SERVICE BULLETIN

Classification: BR98-010	Reference: NTB98-090	Date: November 15, 1998
-----------------------------	-------------------------	----------------------------

1995-99 MAXIMA REAR BRAKE SQUEAK/SQUEAL NOISE WHEN COLD

APPLIED VEHICLE: 1995-99 Maxima (A32)
APPLIED DATE: Vehicles built before August 4, 1998

Figure 1

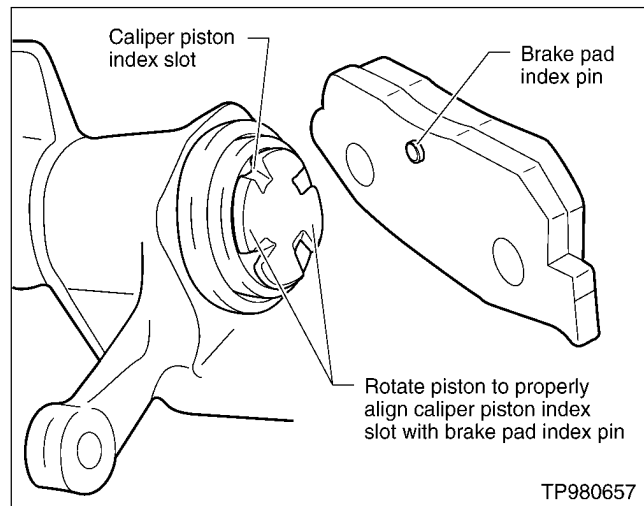
- When installing the rear pads to the caliper, be sure to rotate the piston to properly align one of the caliper piston index slots with the index pin on the brake pad (see Figure 1).
